**SUNDRY NOTICES AND REPORTS ON WELLS**  
*Do not use this form for proposals to drill or to re-enter an abandoned well. Use form 3160-3 (APD) for such proposals.*

8. Well Name and No.  
HH SO 17 20 FED 002 4H

Chevron USA Inc respectfully requests the following changes to the original APD approved 7/6/2018:

**Delaware Basin  
Changes to APD/COA for Federal  
Well**

Drilling Sequence & Slot Designation

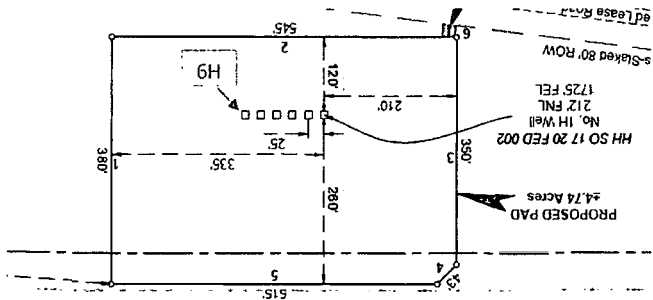
- A variance from the Onshore Order 2 where it states "(A full BOP Test) shall be performed: when initially installed and whenever any seal subject to test pressure is broken." We propose to break test if able to finish the next hole section within 21 days of the previous full BOP test. Upon the first nipple up of the pad a full BOP test will be performed. A break test will consist of a 250 psi low /  $\geq$  5,000 psi high 10 min ea test against the connection that was broken when skidding the rig. A break test will not be performed on our last production section. A break test will only be performed on operations where BLM documentation states a 5M or less BOP can be utilized.

See drilling sequence below that indicates the potential hole sections break testing can be performed given they meet the above criteria.
